**Request for Additional Information No. 20, Revision 0**

**7/28/2008**

**U.S. EPR Standard Design Certification**

**SRP Section: 09.05.01 - Fire Protection Program**

**Figure 9.5.1-1—Fire Water Distribution System  
Sheet 5 of 13**

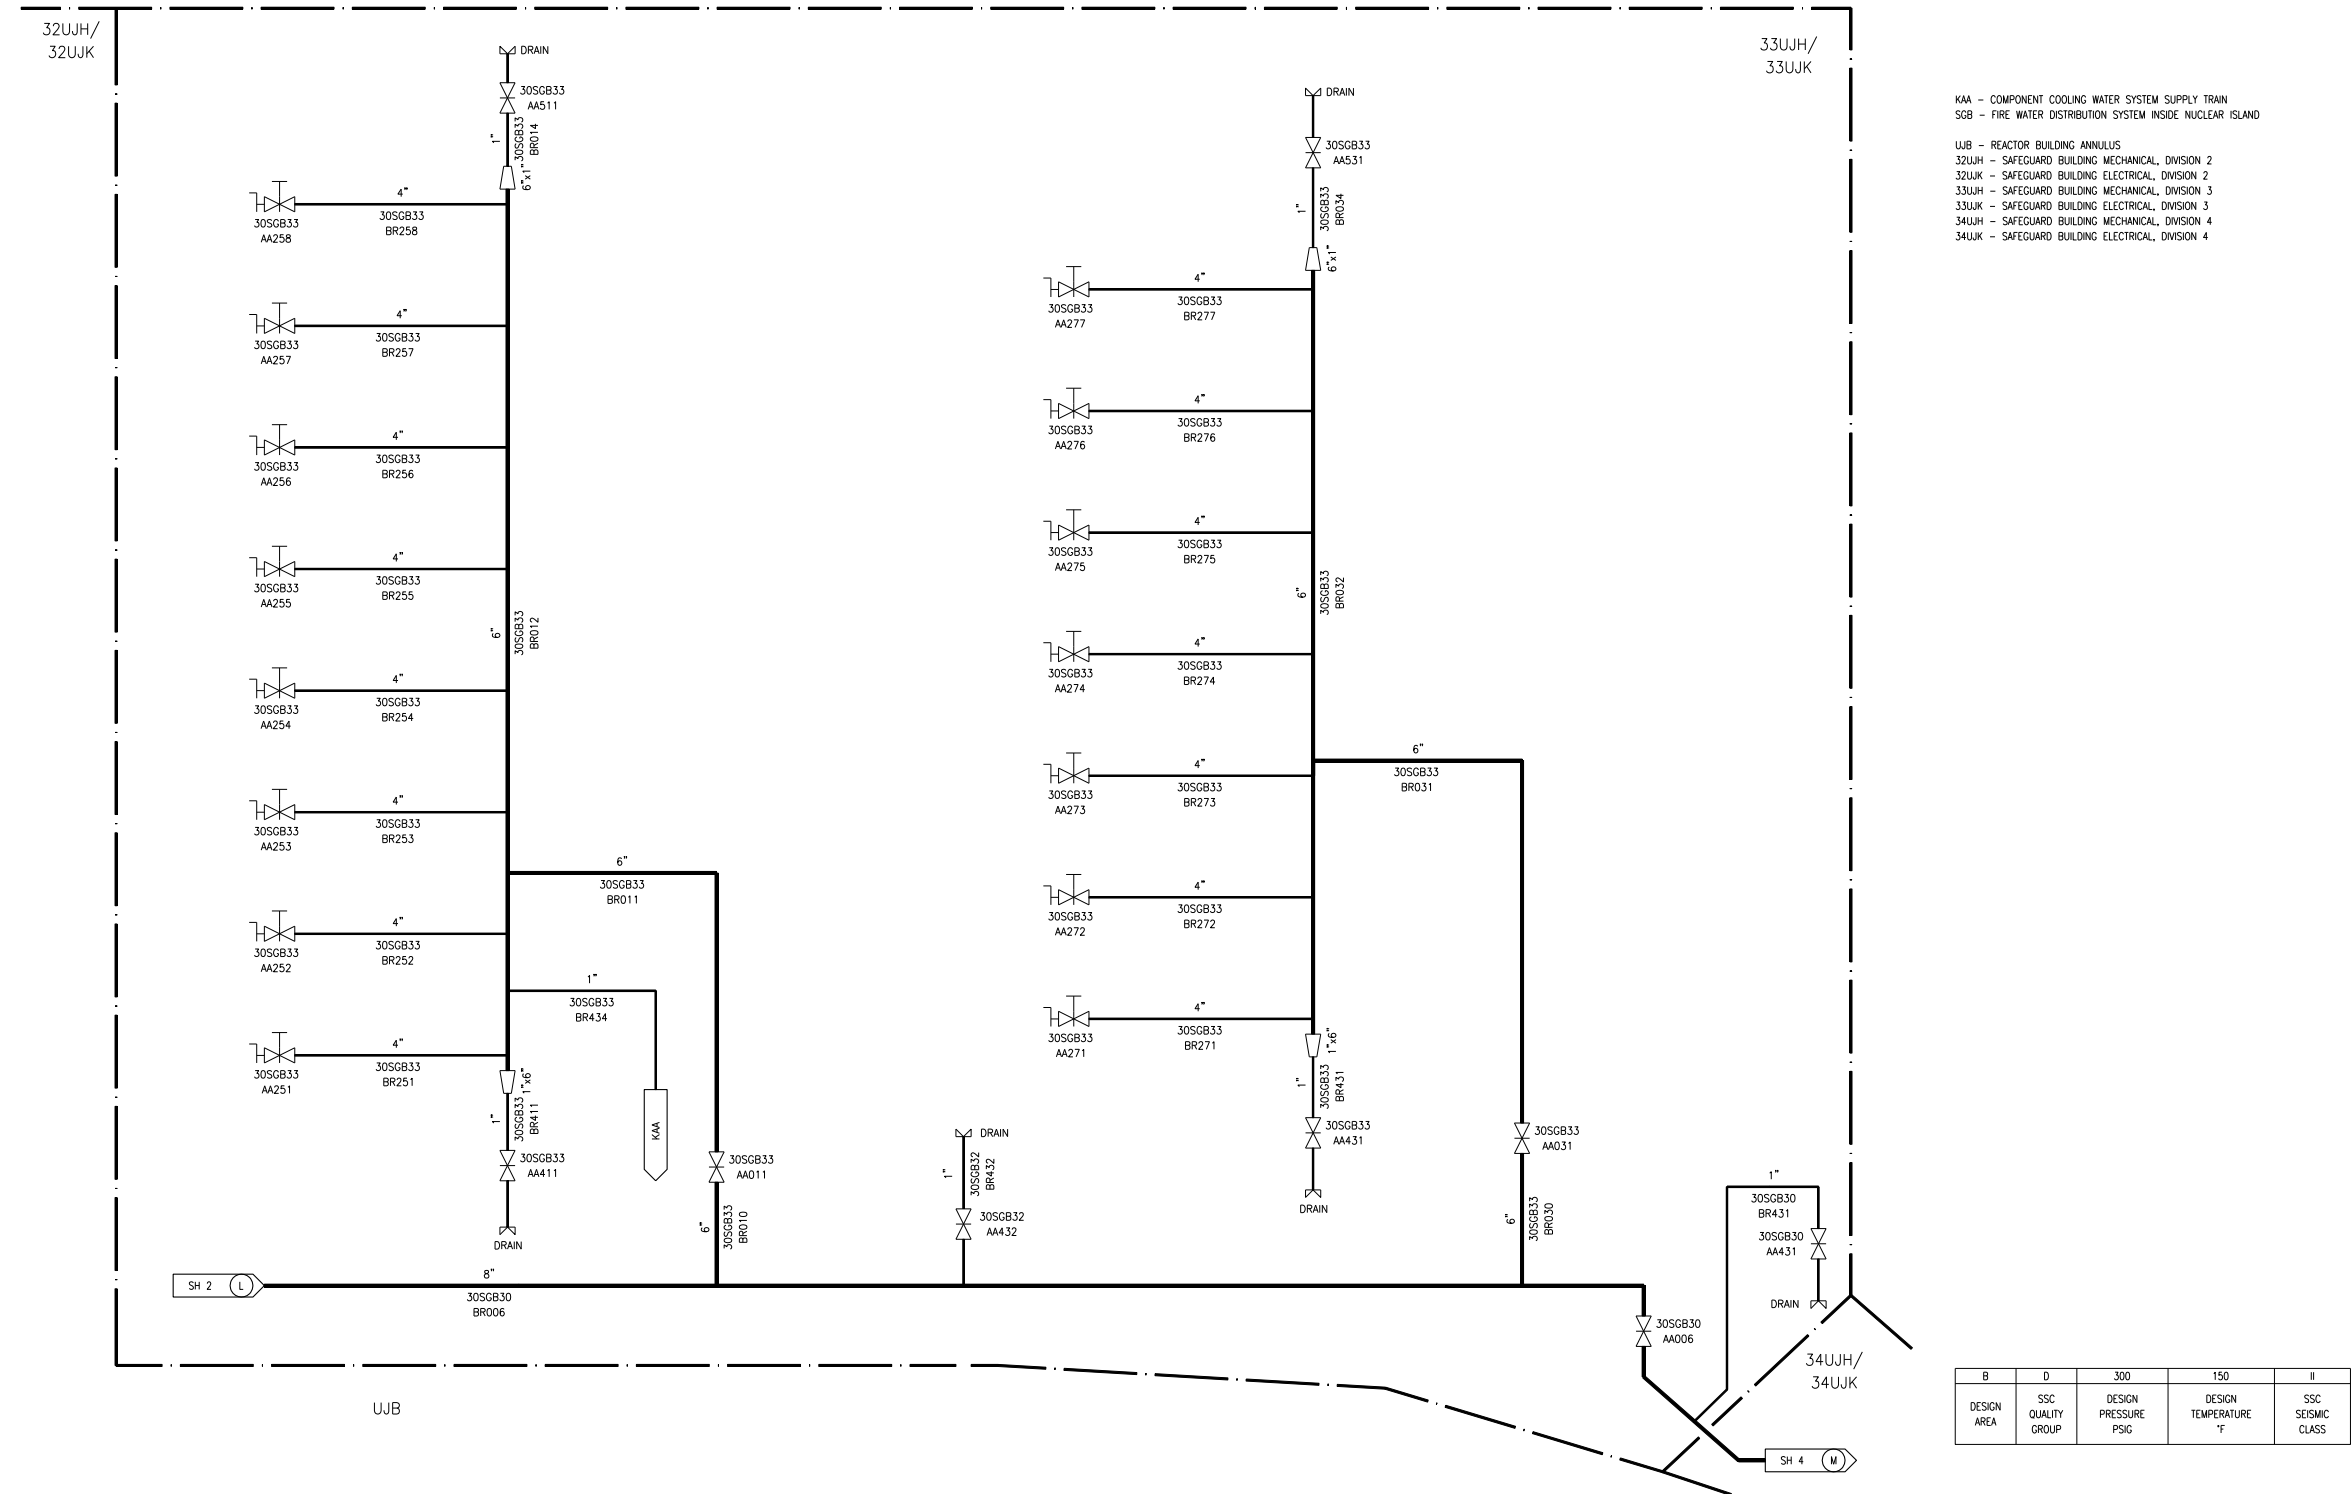
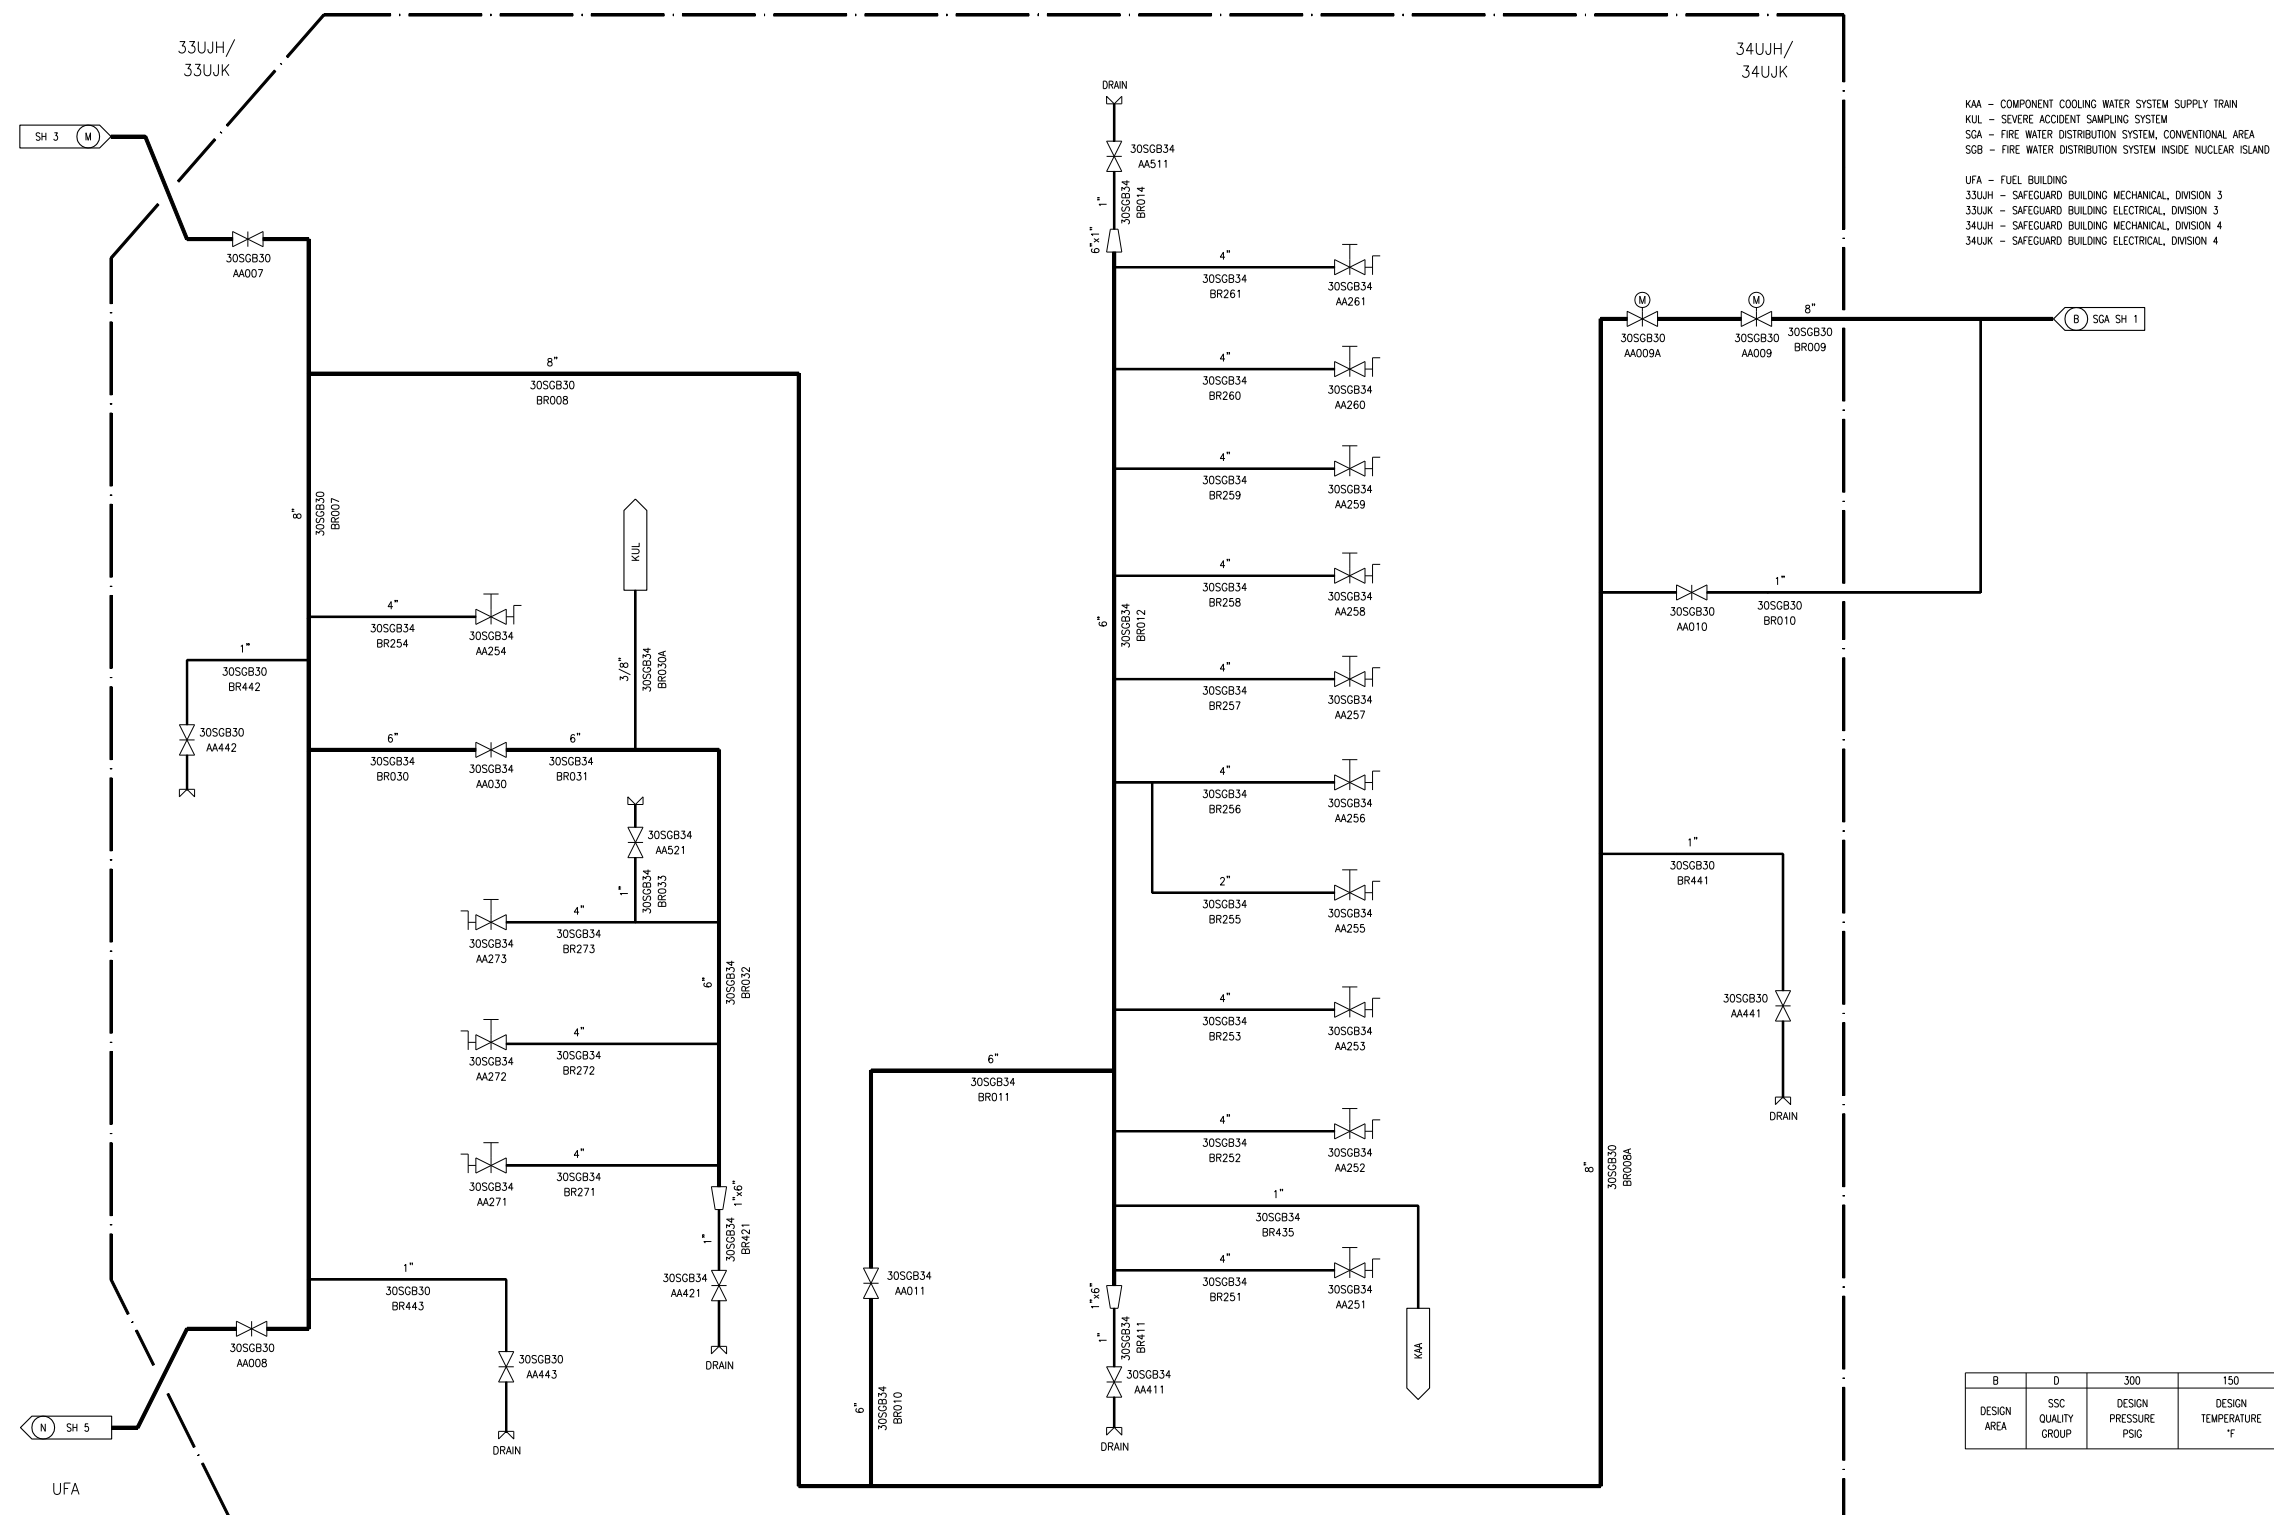
The EPR FSAR should add a COL information item to provide simplified FPS piping and instrumentation diagrams showing complete site-specific systems. Nuclear Island definition is different in Figure 9.5.1-1 then in Tier 1 Section 2.1.1. Modify FSAR accordingly. Basis: Completeness of application.

U.S. EPR FSAR Tier 2, Figure 9.5.1-1 depicts the fire water distribution system for the Nuclear Island (NI) and plant areas not considered part of the NI. However, the current title for this figure is "Fire Water Distribution System Inside Nuclear Island."

The title for U.S. EPR FSAR Tier 2, Figure 9.5.1-1 will be changed to "Fire Water Distribution System." The reference to this figure in U.S. EPR FSAR Tier 2, Section 9.5.1.2.1, under "Fire Water Supply System," will be revised to reflect the new title identified above.

U.S. EPR FSAR Tier 2, Section 9.5.1.2.1 will be revised as described in the response and indicated on the enclosed markup. U.S. EPR FSAR Tier 2, Figure 9.5.1-1 will be revised as described in the response and indicated on the enclosed markup. U.S. EPR FSAR Tier 2, Table 1.8-2 will be revised as described in the response and indicated on the enclosed markup.
